FINAL DRAINAGE PLAN

THE RIDGE AT LORSON RANCH

JANUARY, 2022

Core Engineering Group, LLC
15004 1ST Avenue South
Burnsville, MN 55306
(719) 570-1100

POND C2.1 FULL SPECTRUM OUTLET STRUCTURE DETAILS

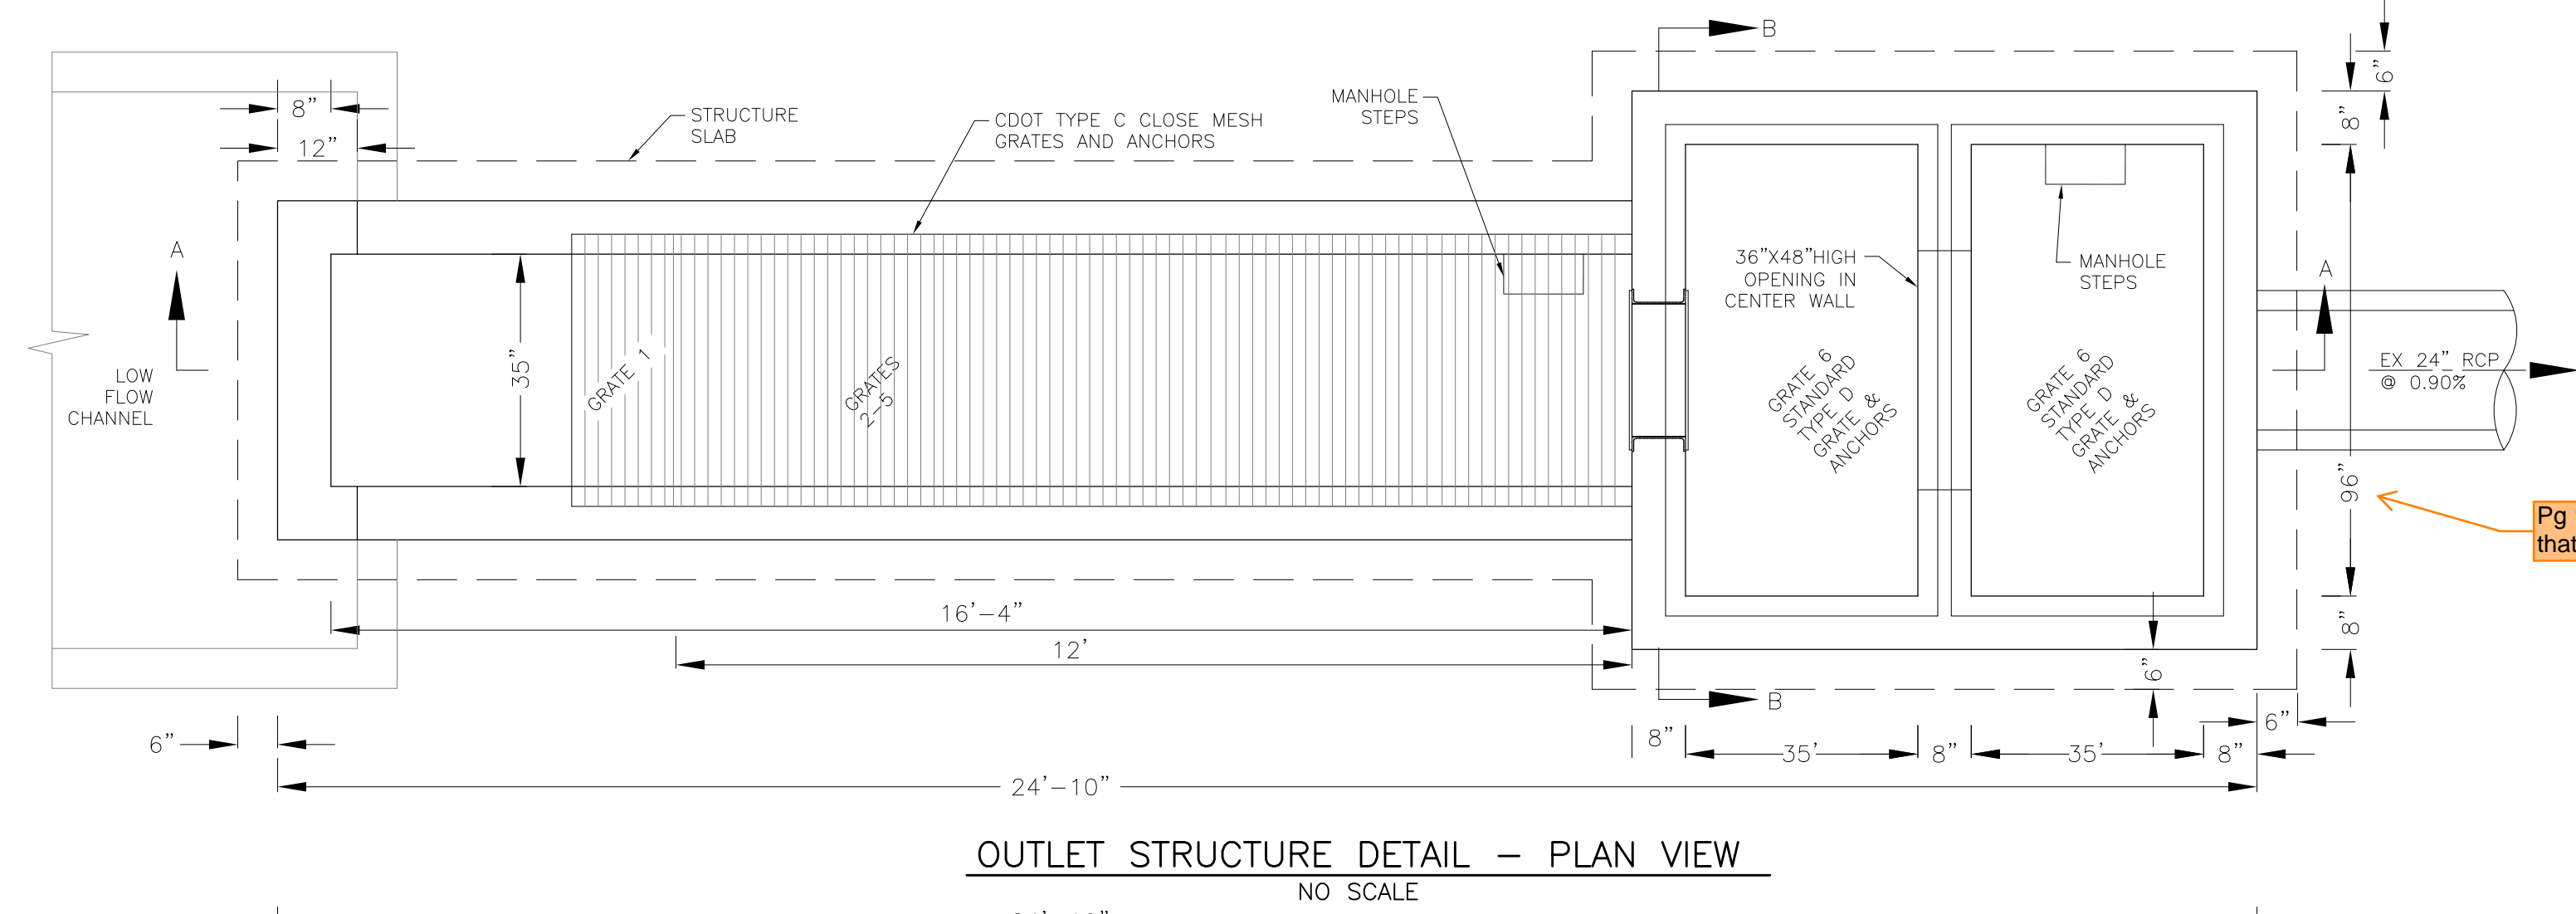
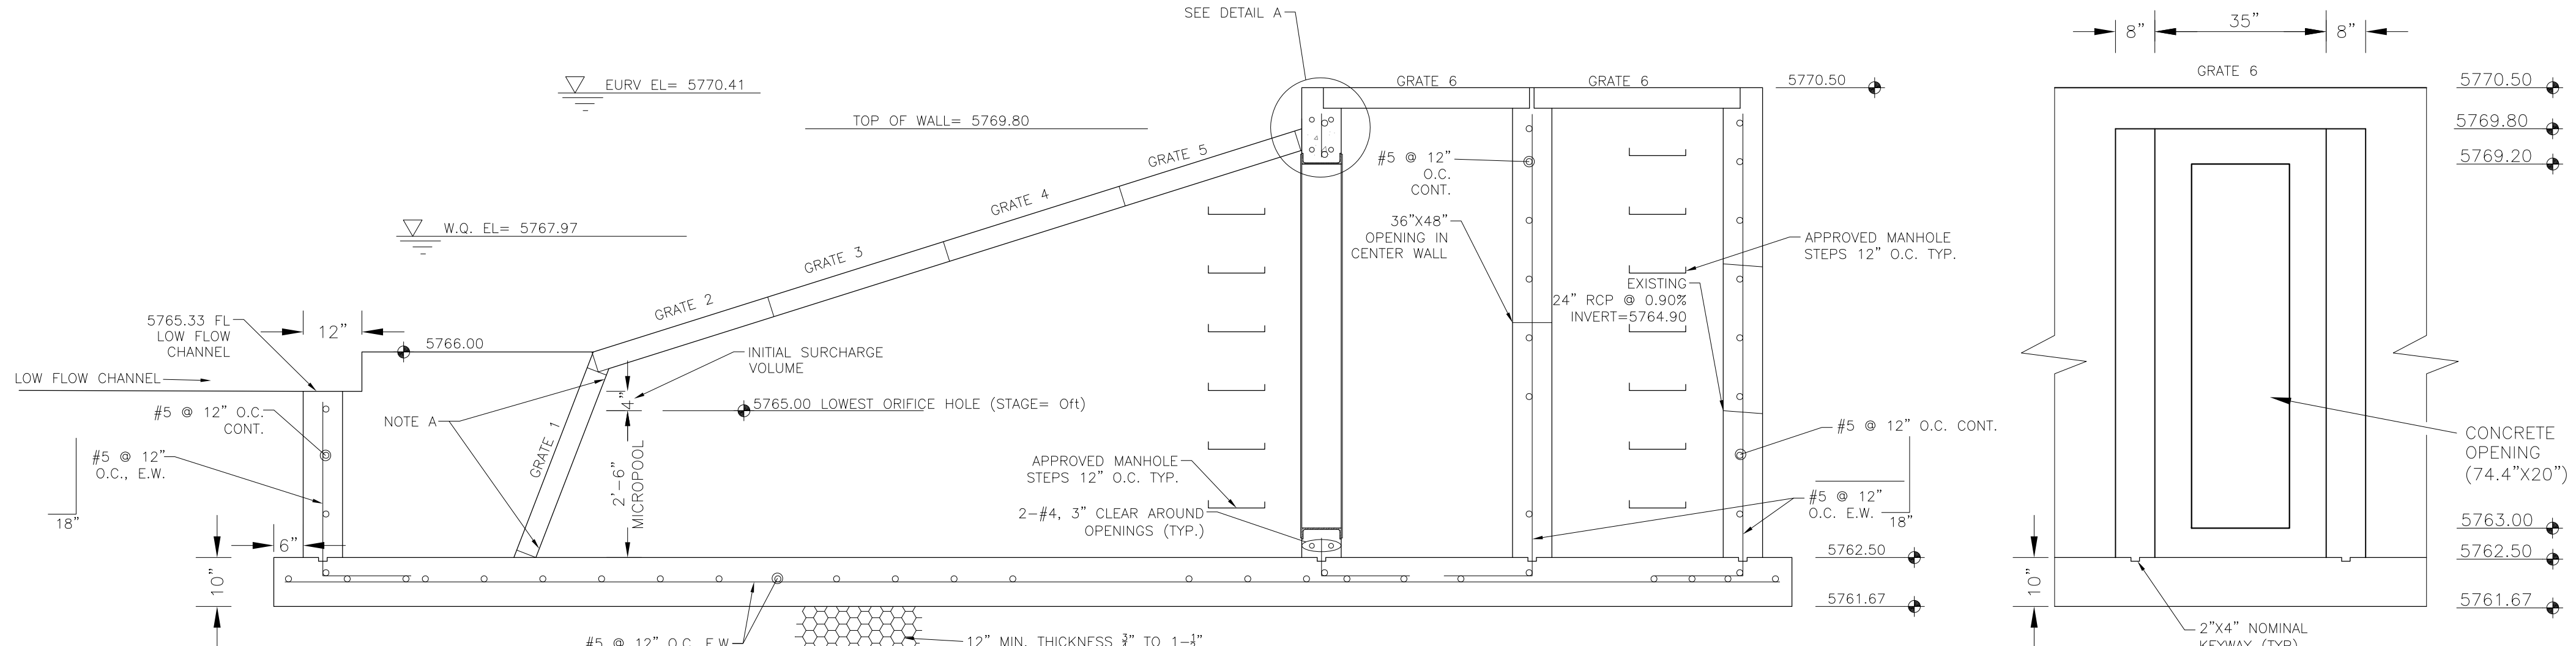
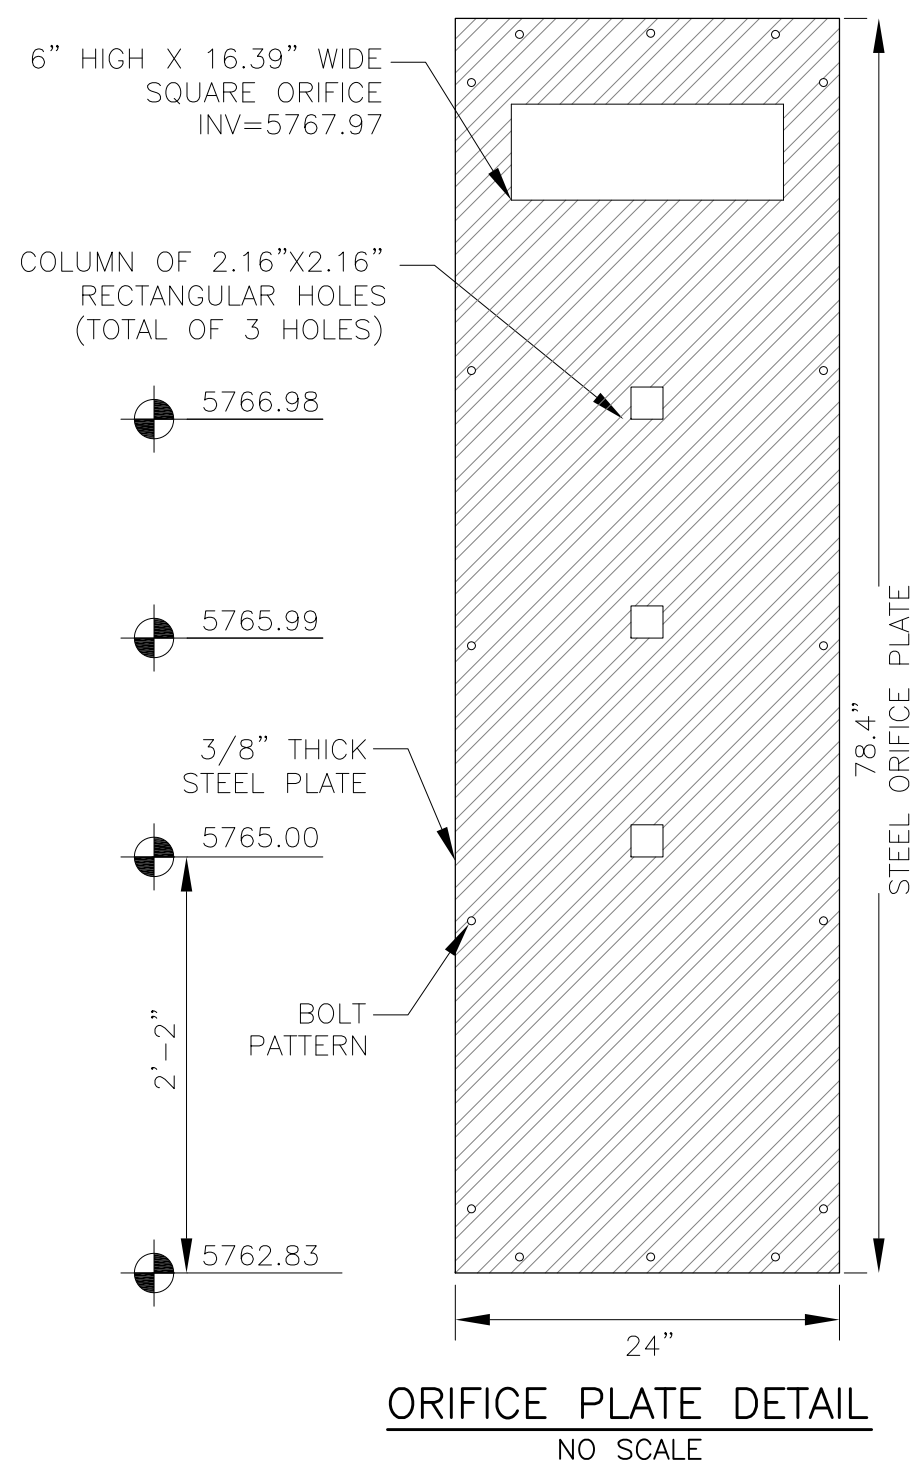
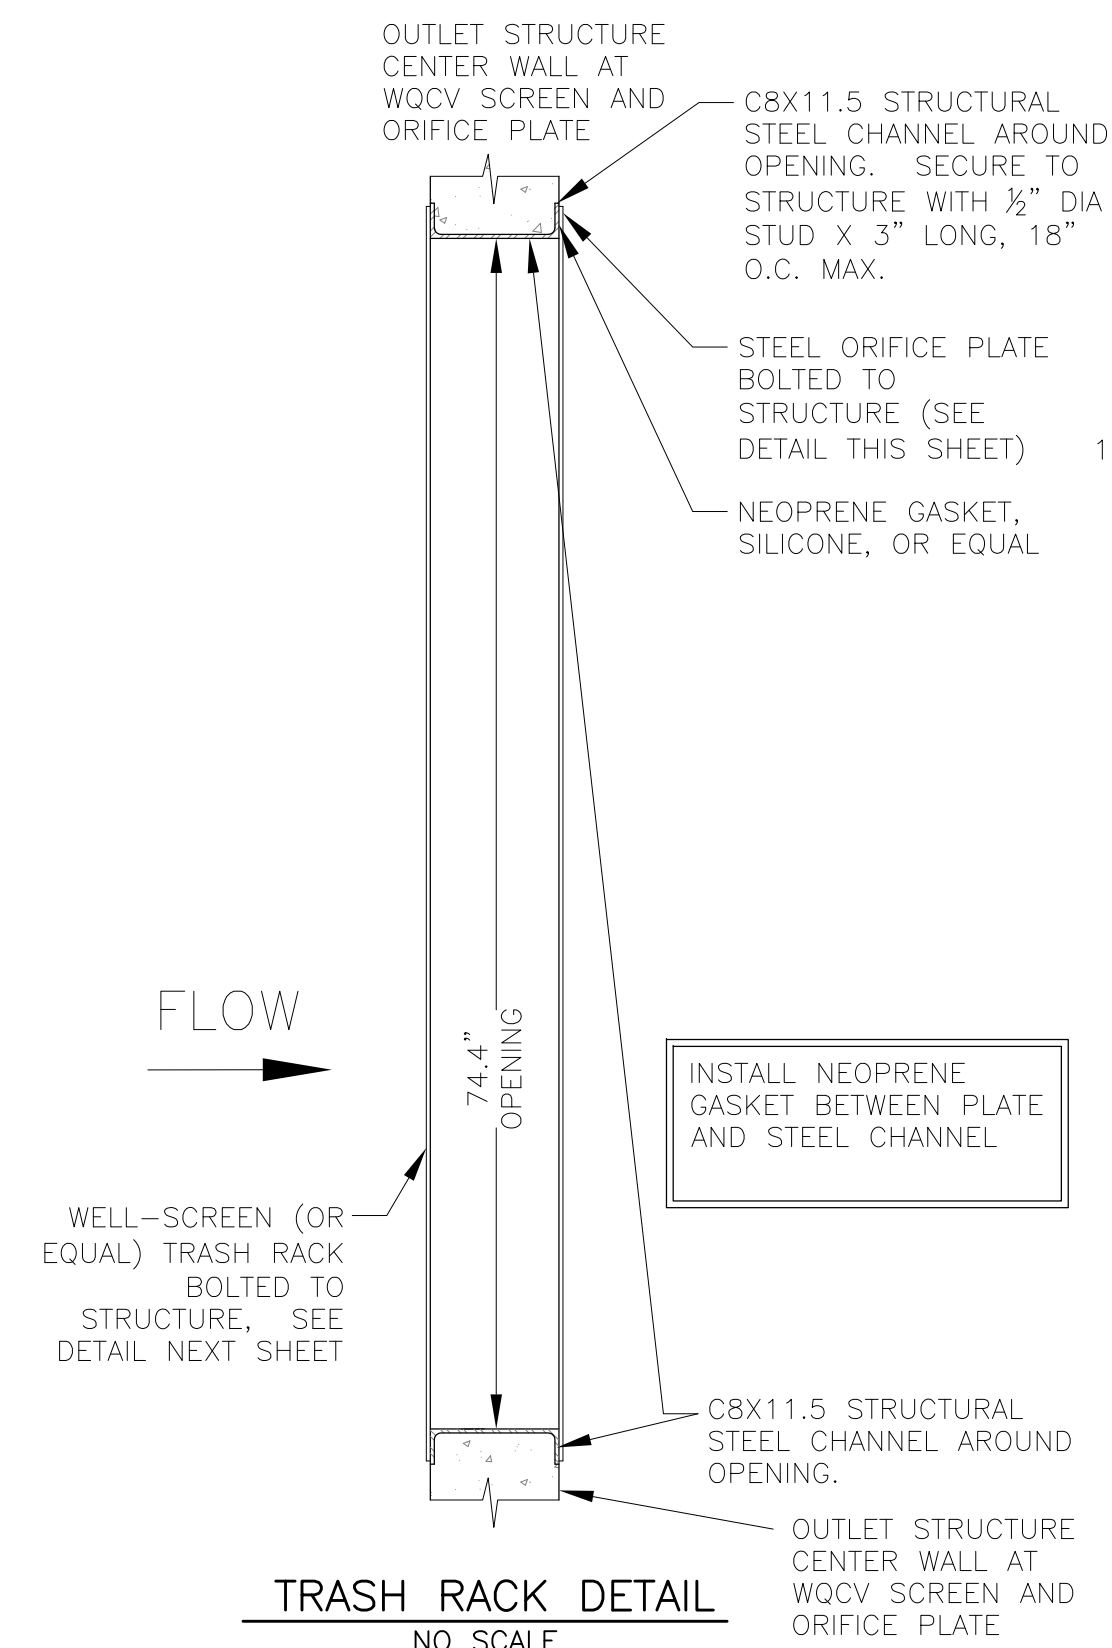
Pg 190 above shows
that this should be 72"

BASINS C8.7 STORM SCHEMATIC

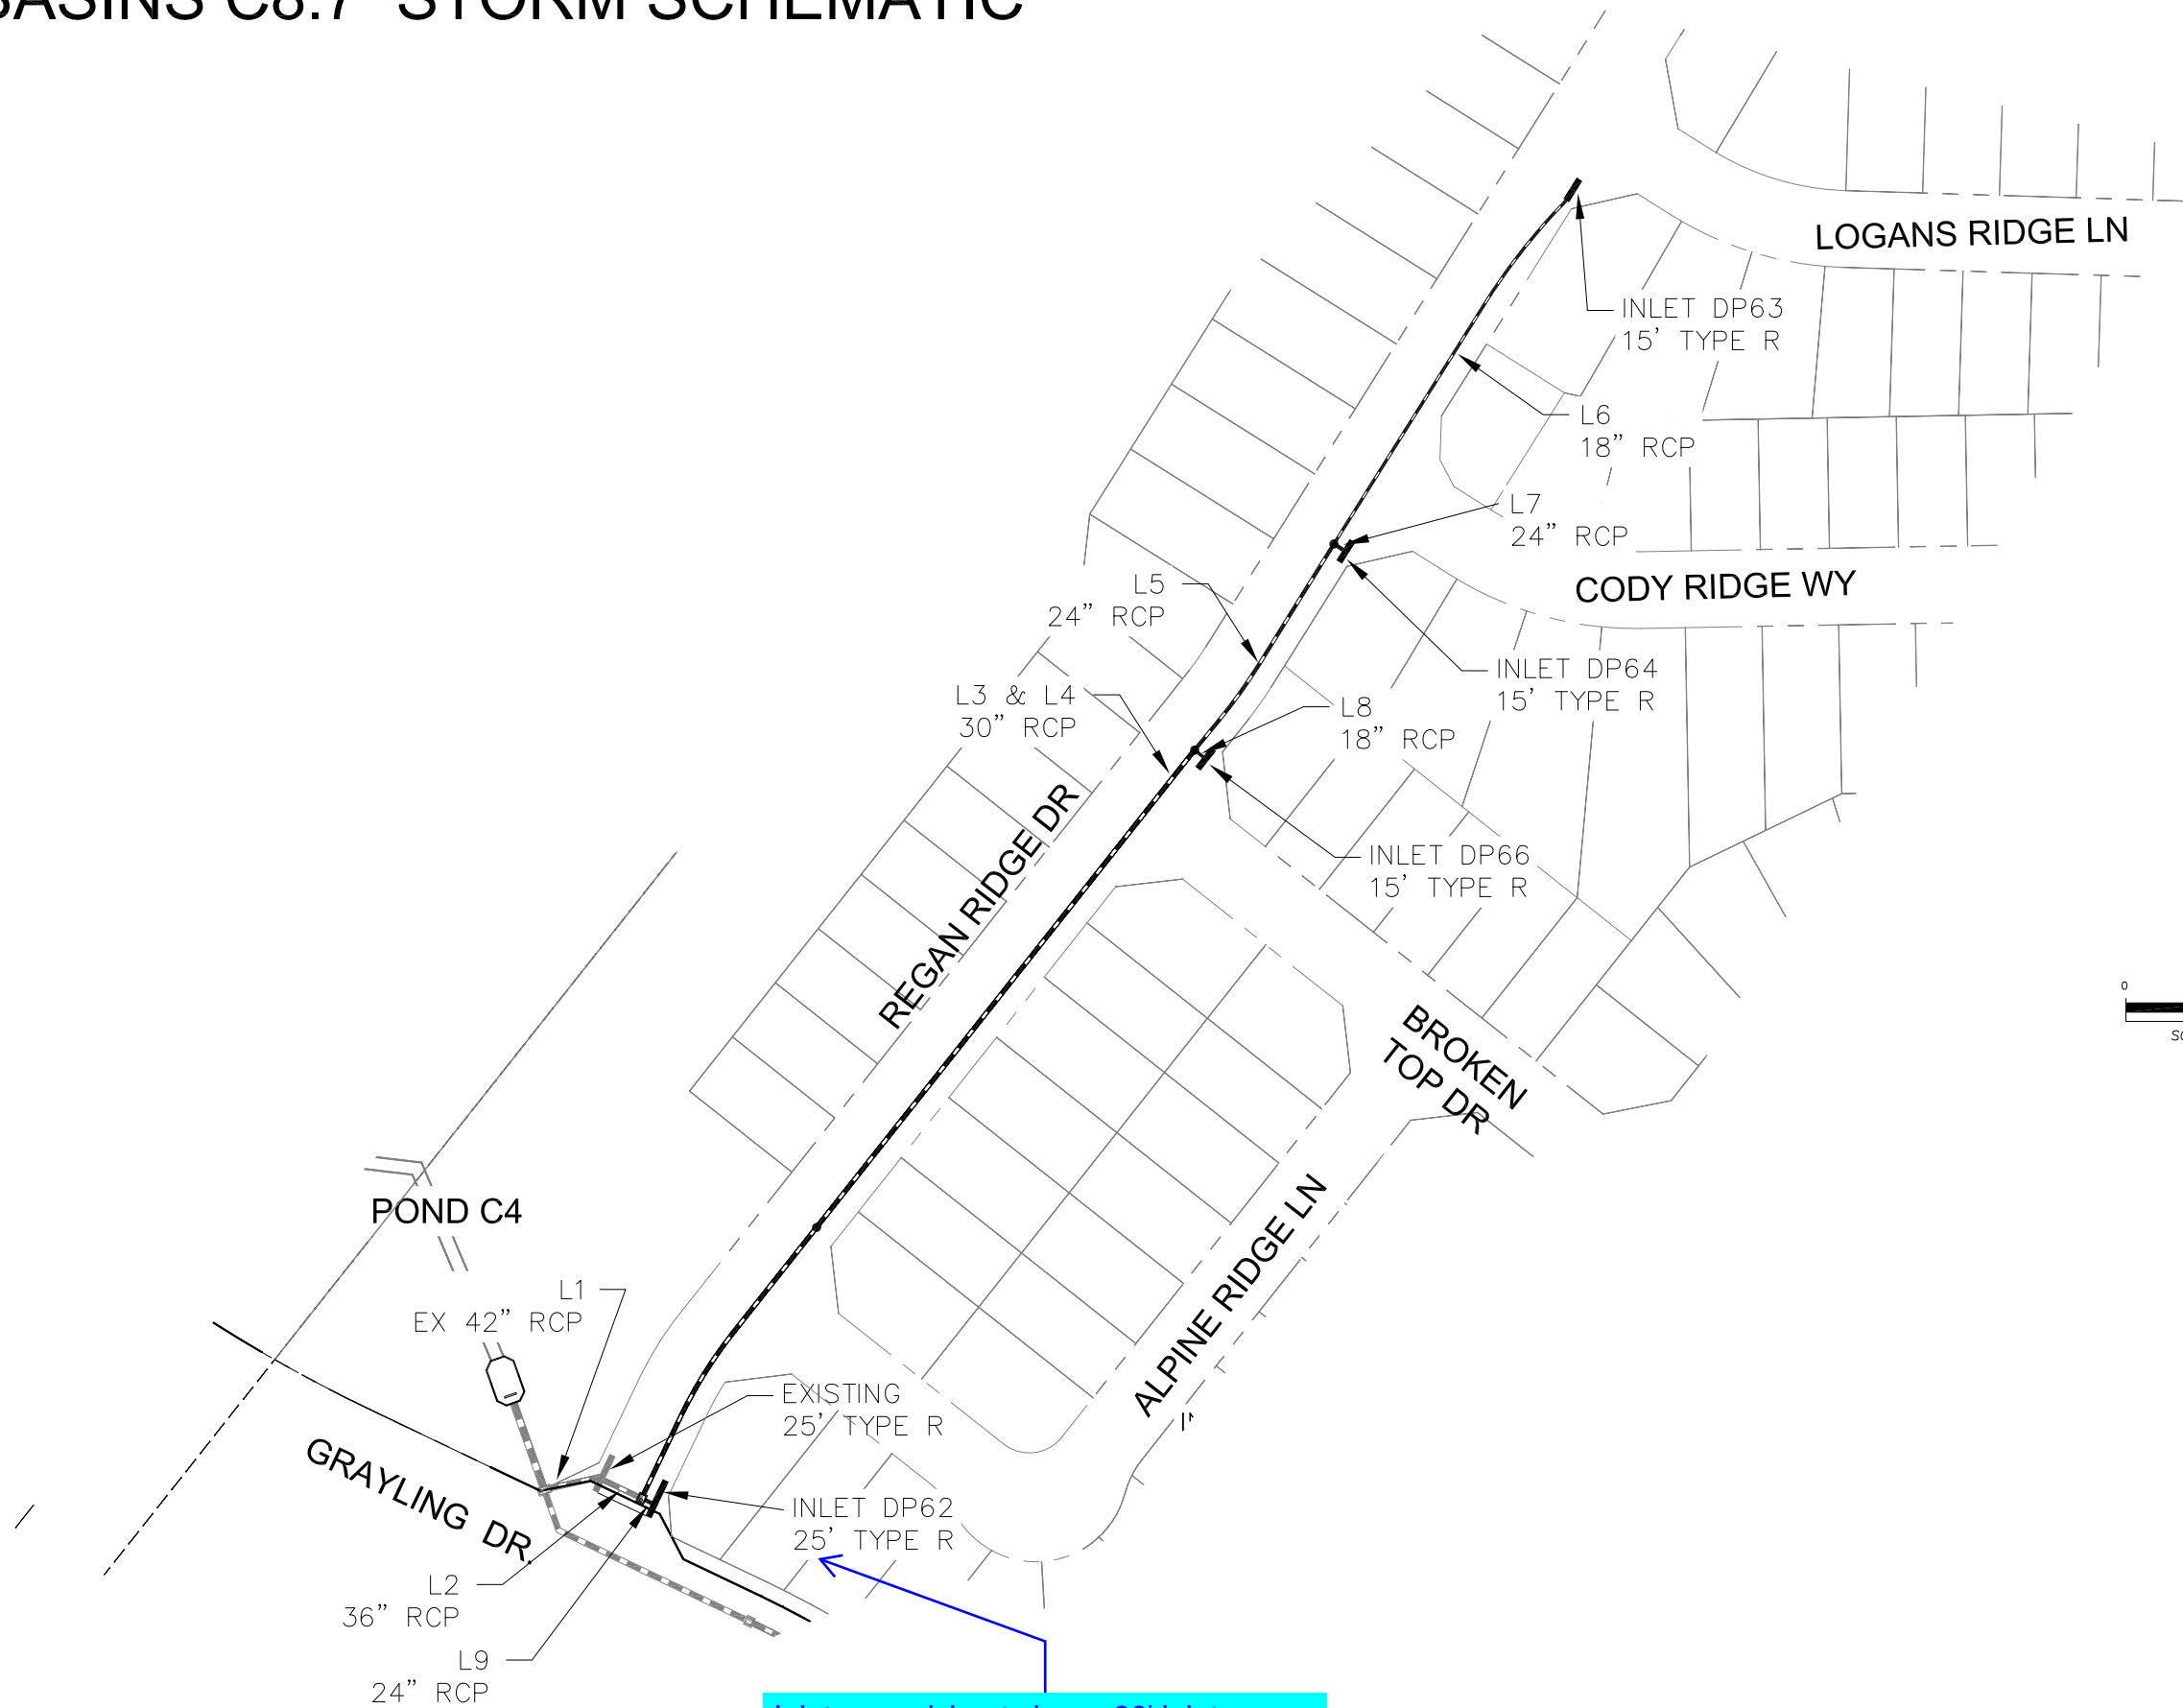
Inlet spreadsheet shows 30' inlet. Revise accordingly to match correct size between storm sewer design, inlet design and drainage map
